Addendum #001

April 21, 2026

New Jetson Center for Youth
Baker, Louisiana
Project # 08-403-04-02, F.08000078, 08-403-24-01, F.08000165

1 SITE CLEARING & PHASE I EROSION CONTROL PLAN
Scale: 1" = 50'

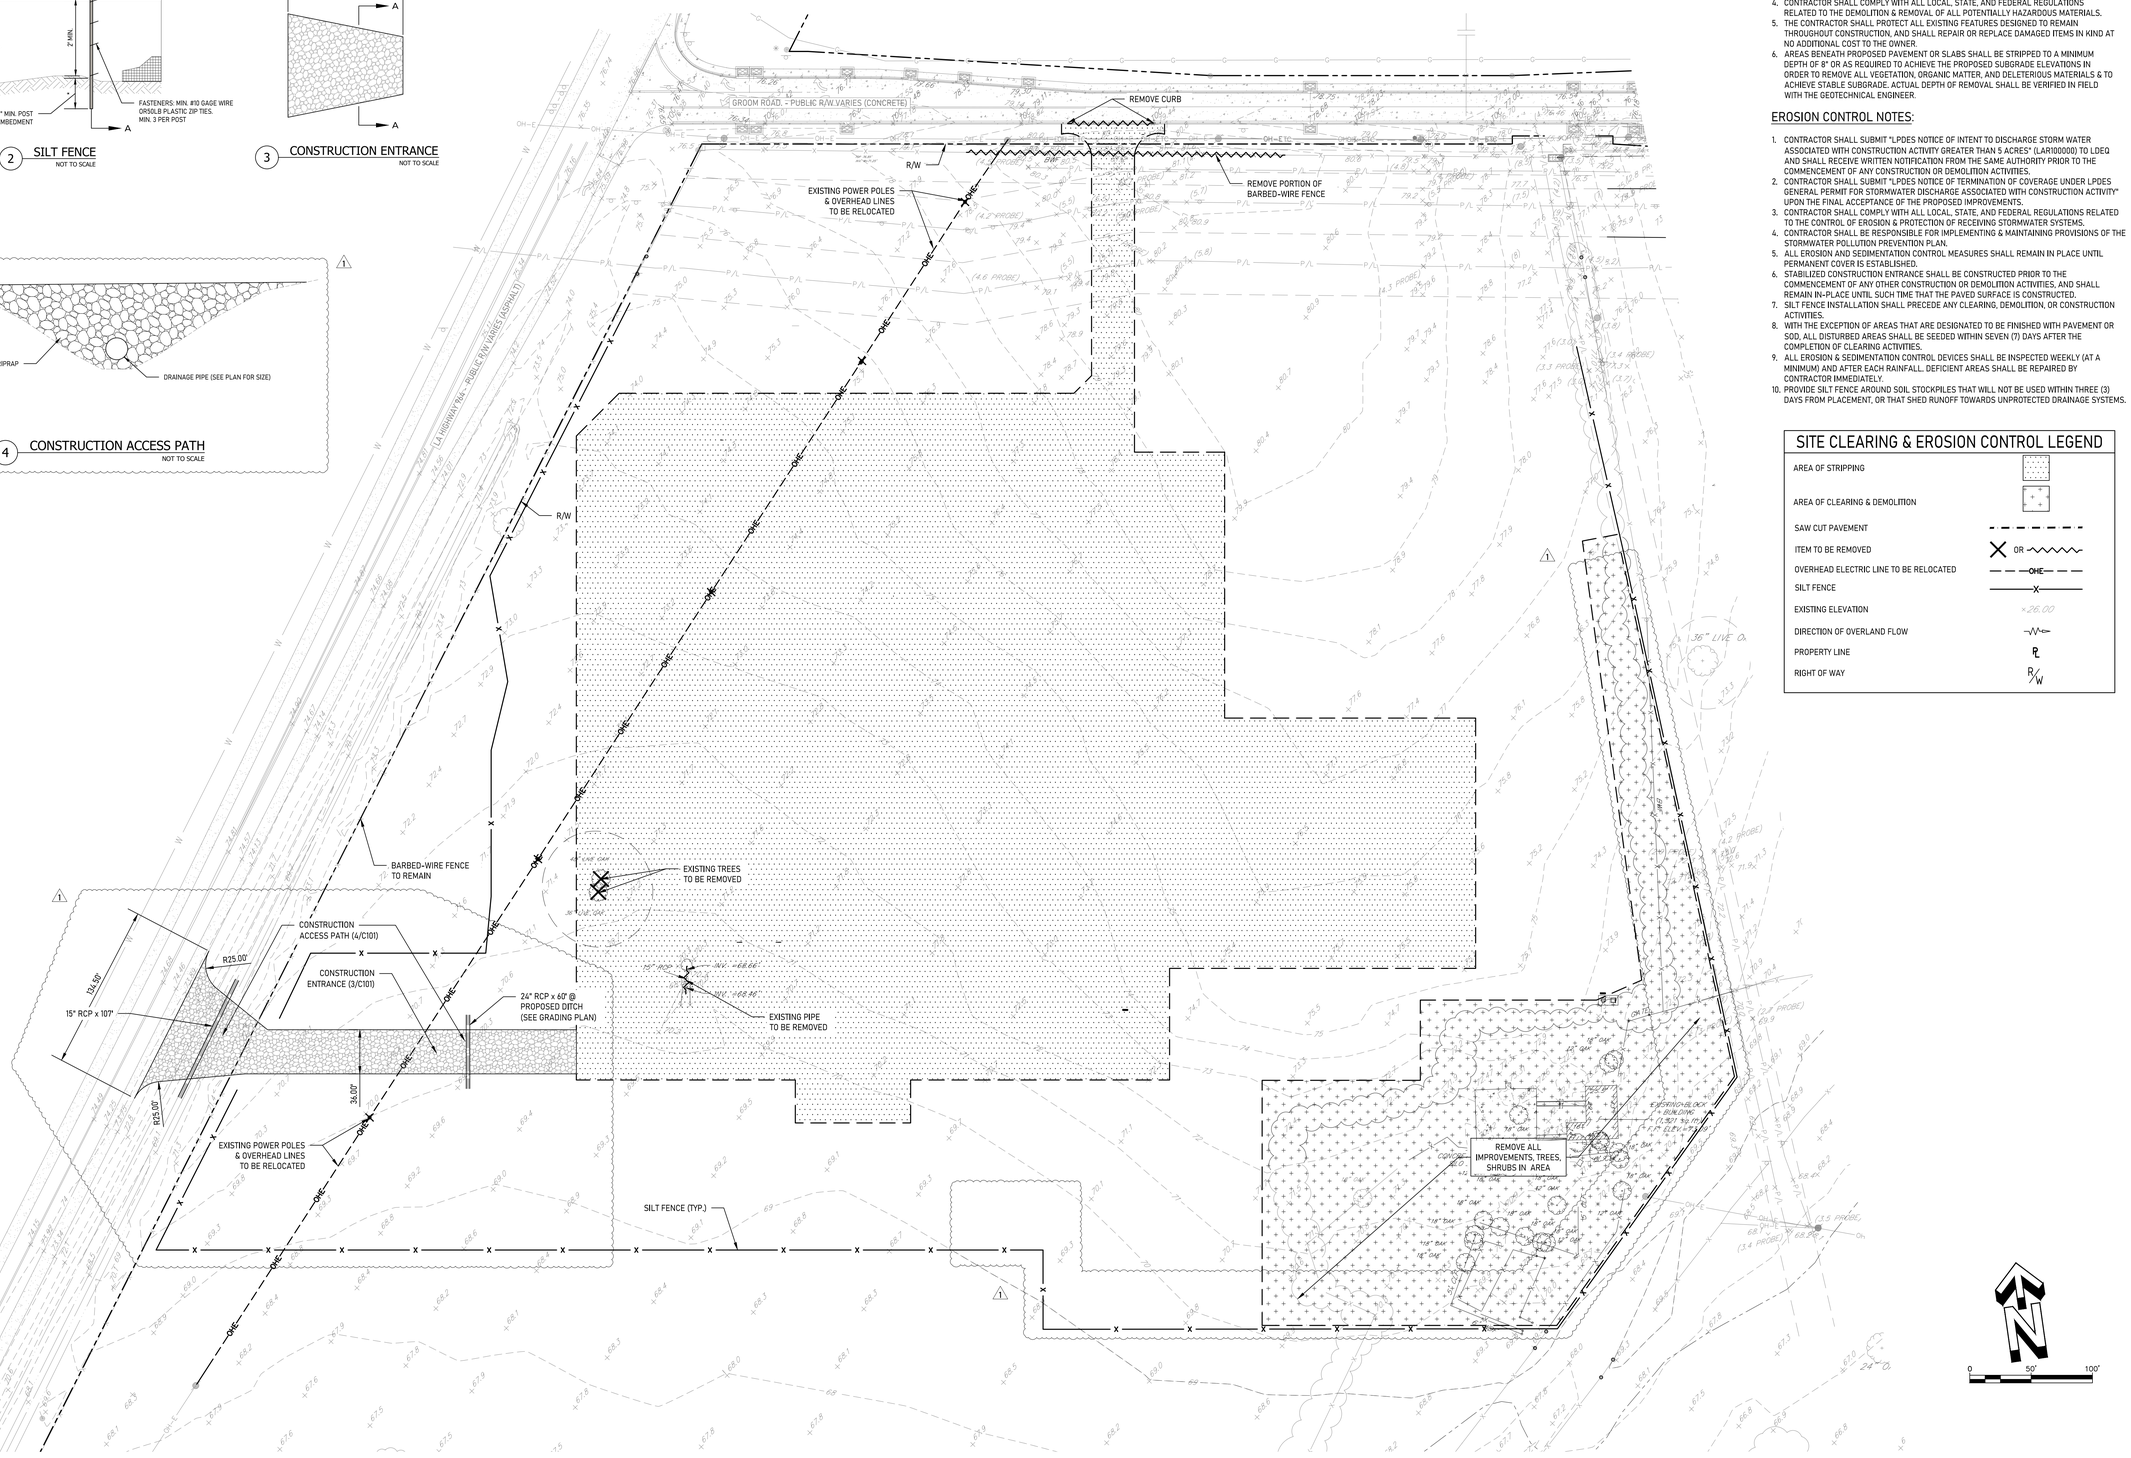
1. **SHEET C101 – SITE CLEARING & PHASE 1 EROSION CONTROL PLAN**
   a. Site Clearing Plan has been **REIVSED** to indicate contractor's temporary drive & is being **REISSUED** as part of this Addendum.

1 STORM DRAINAGE & UTILITY LAYOUT
Scale: 1" = 30'

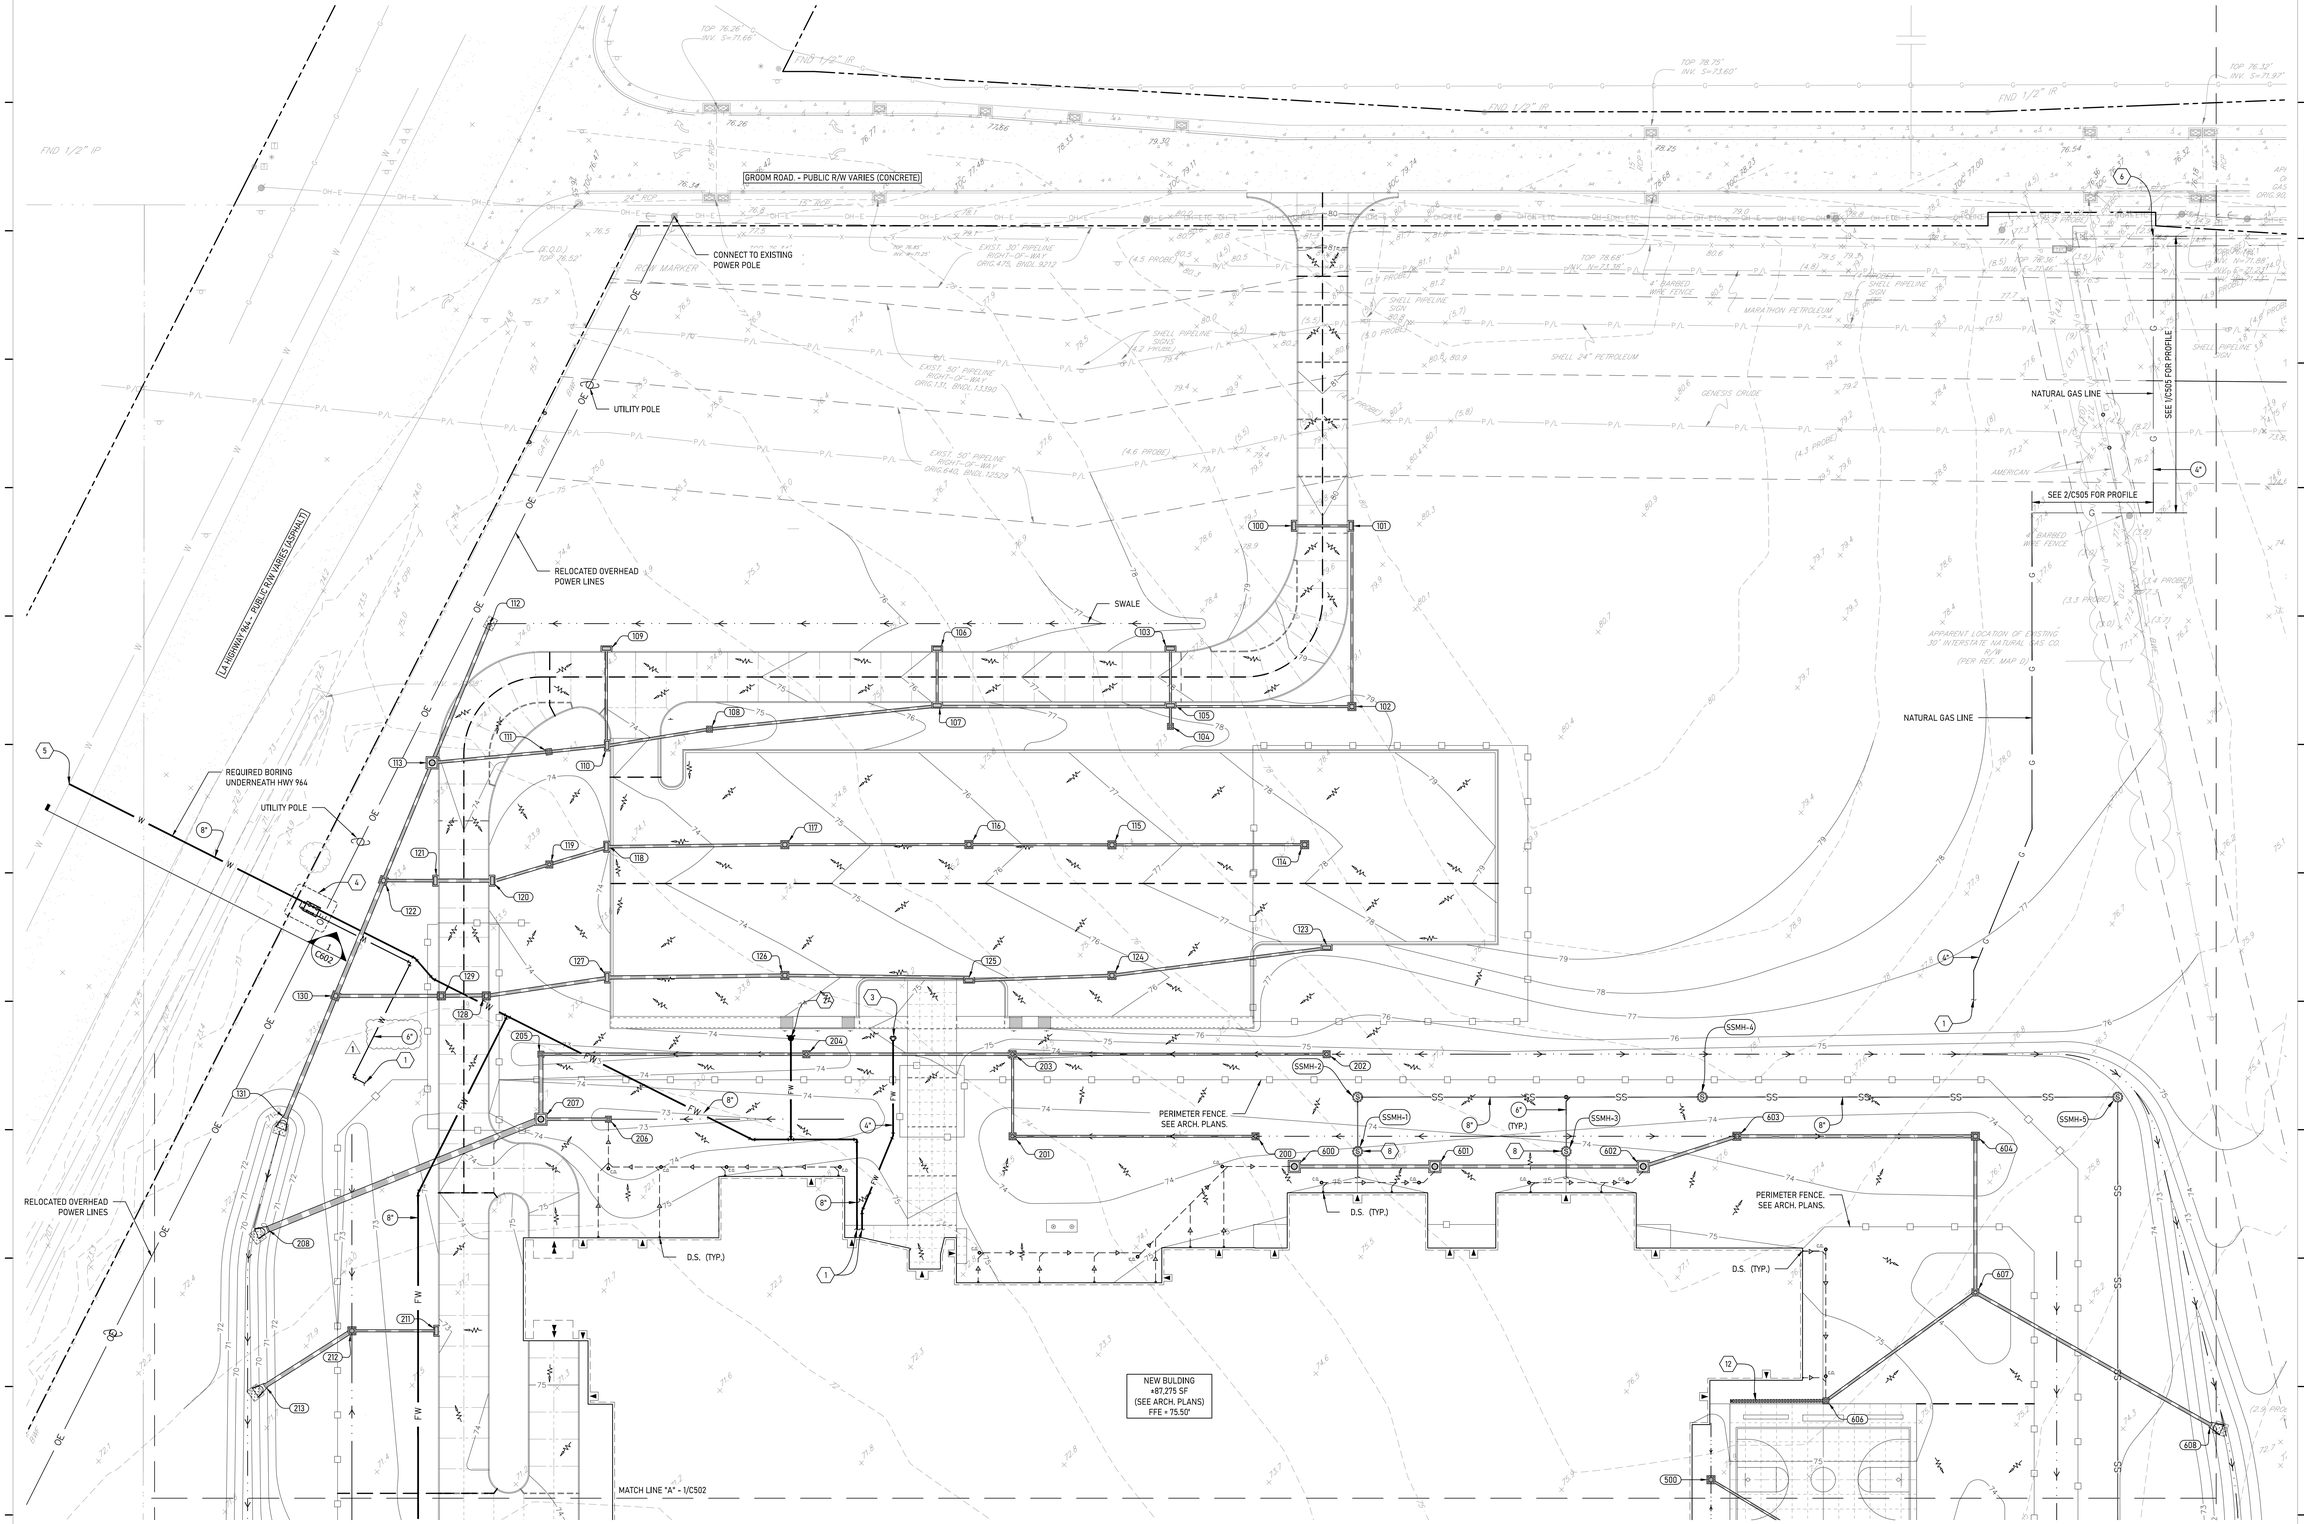
11. **RFI Question:** Water Utilities. Civil Drawing C501 shows the Domestic Water Line to be 4" in size. However, Plumbing Drawing P101 shows the Domestic Water to be 6" in size. Please clarify which size the Domestic Water Line needs to be.

2. **SHEET C500 – STORM DRAINAGE & UTILITY INFO**
   a. Drawing Sheet is being **REVISED** and **REISSUED** as part of this Addendum.

Response: Domestic water feed will be 6" per the plumbing plans. Refer to the revised C501.

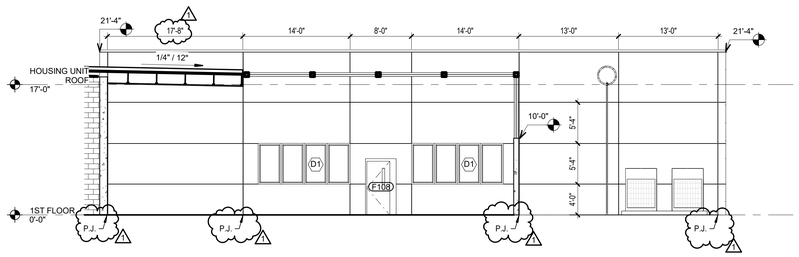
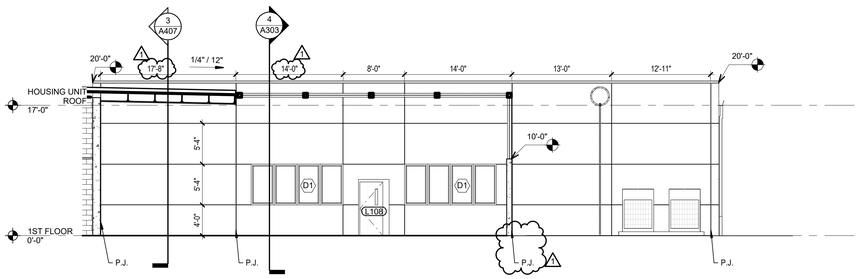
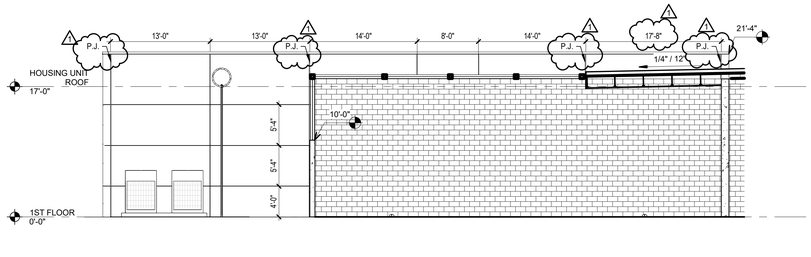
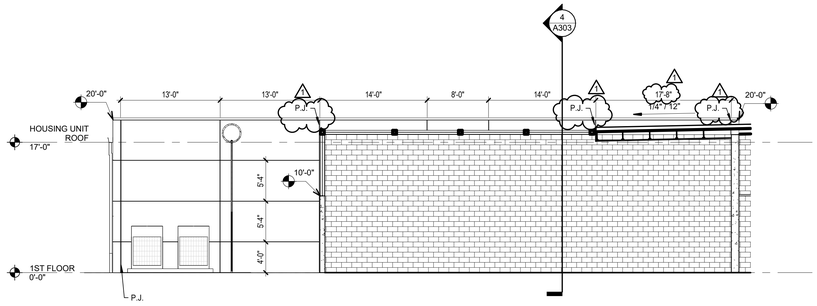
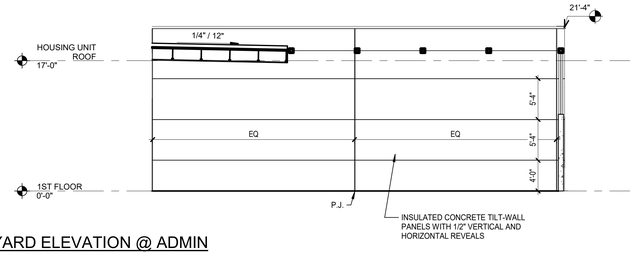
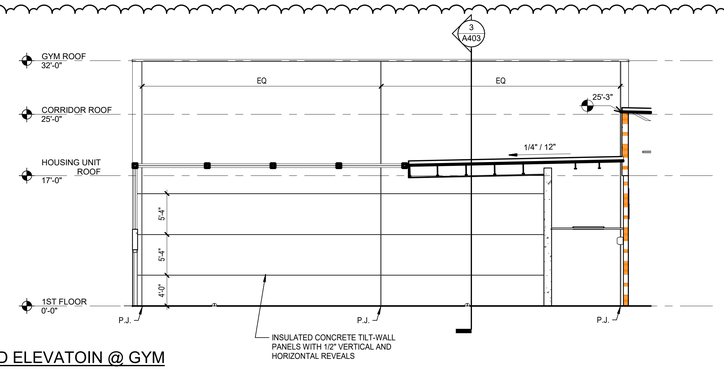
6. **SHEET A204 – BUILDING ELEVATIONS**
    a. Additional Exterior Elevations have been **ADDED** to this sheet, and it is being **REISSUED** as part of this Addendum.

1 SITE ELECTRICAL PLAN
1" = 40'-0" (For 30"x42" Sheet)

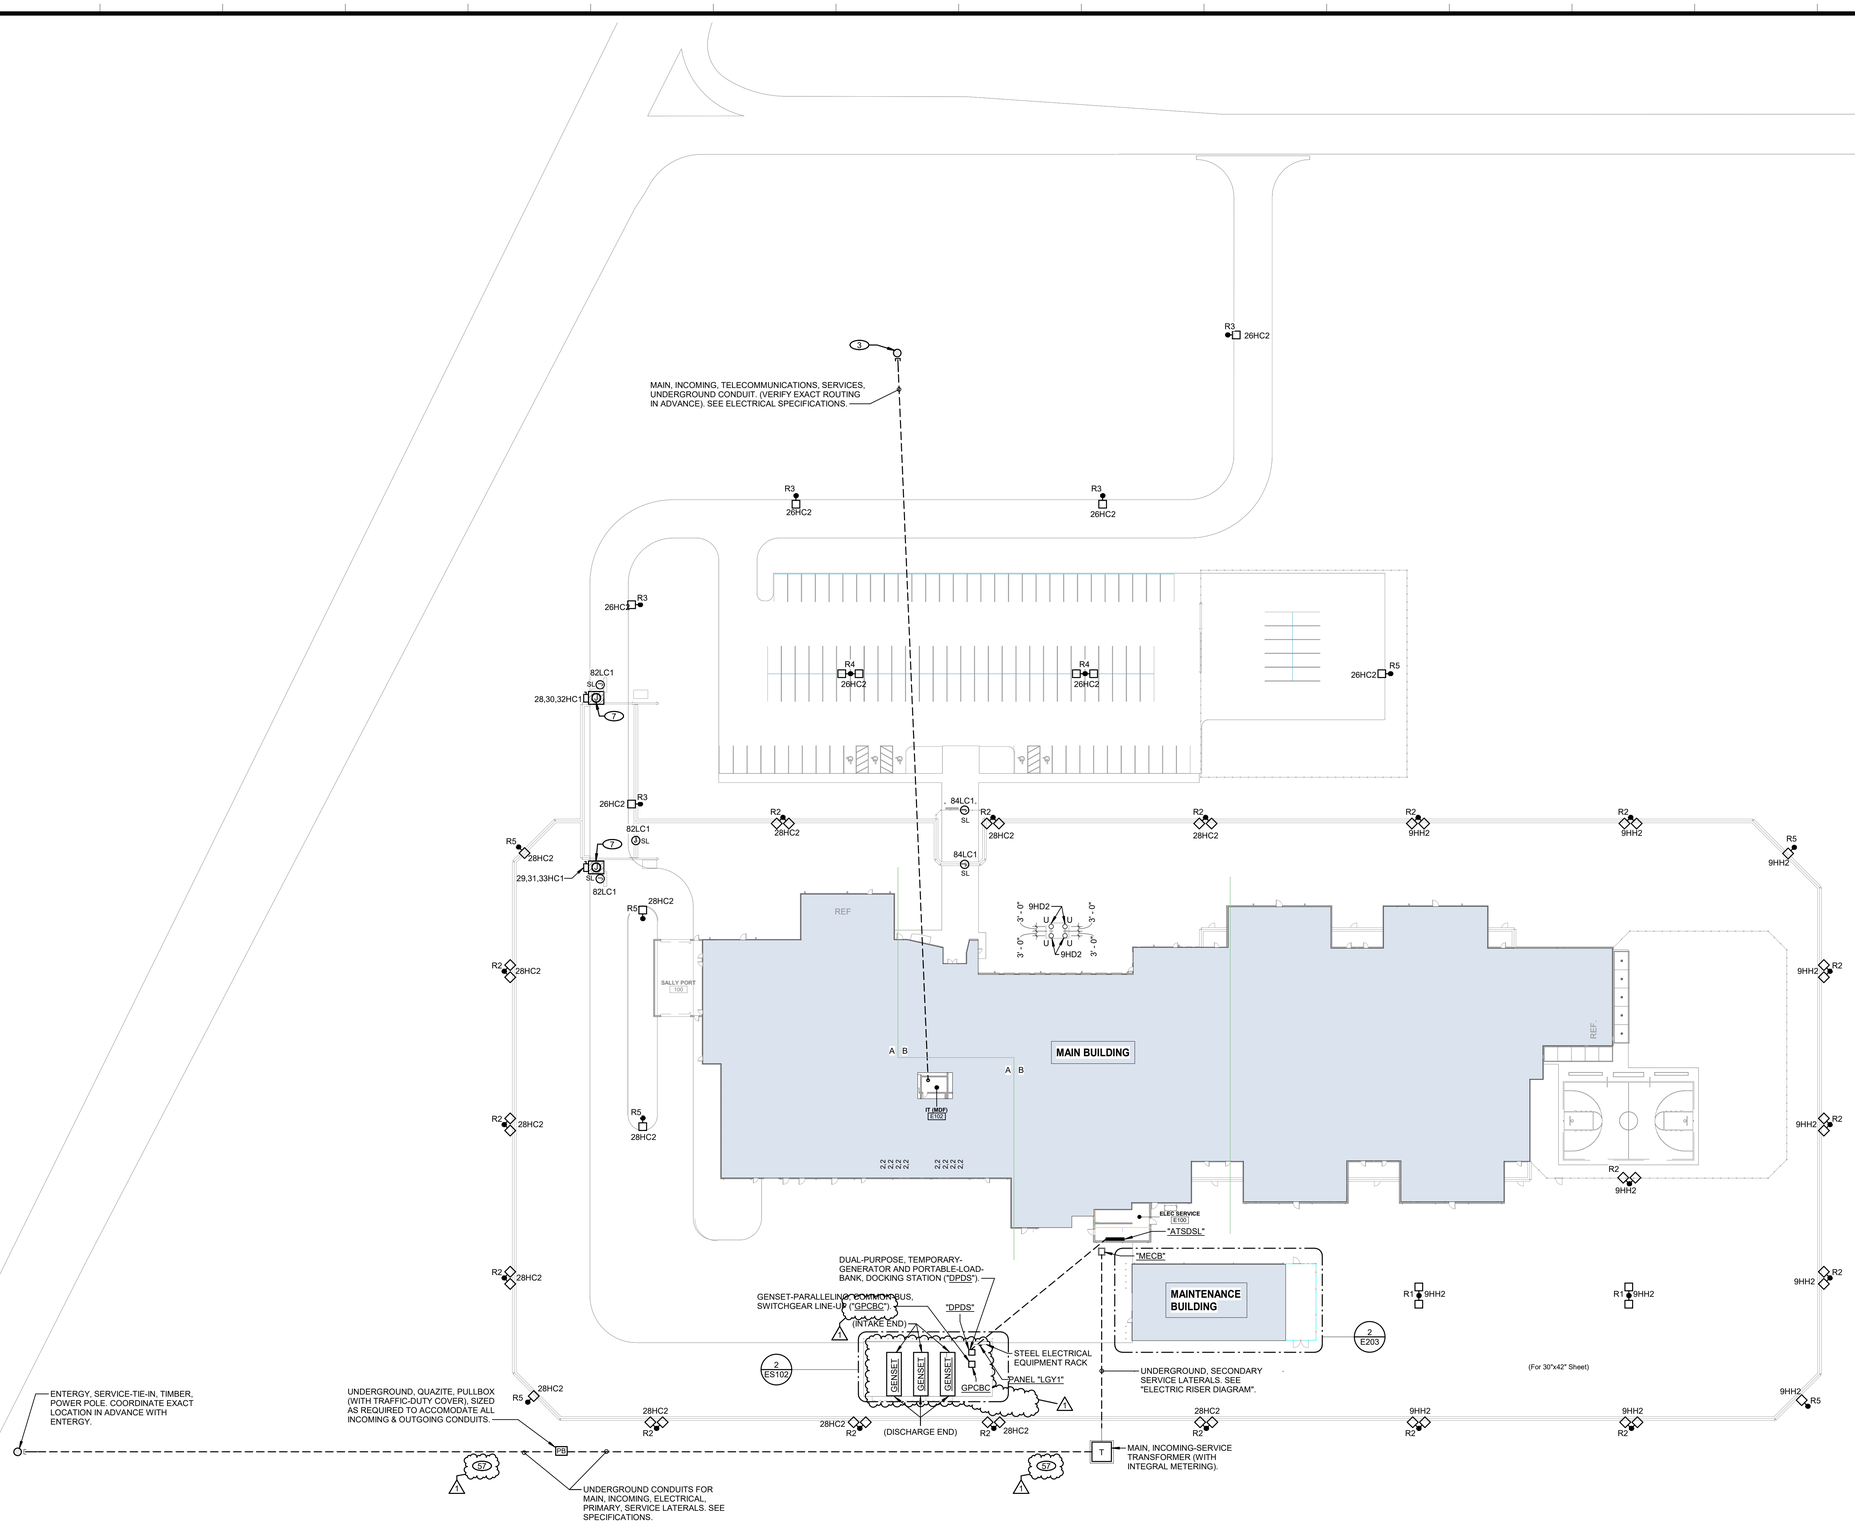
1. **SHEET ES101 – SITE PLAN ELECTRIAL**
    a. Make changes to the “Site Electrical Plan” as shown
2. **SHEET ES102 – SITE ELECRICAL GROUND PLAN & GENERATOR YARD ELECTRICAL PLAN**
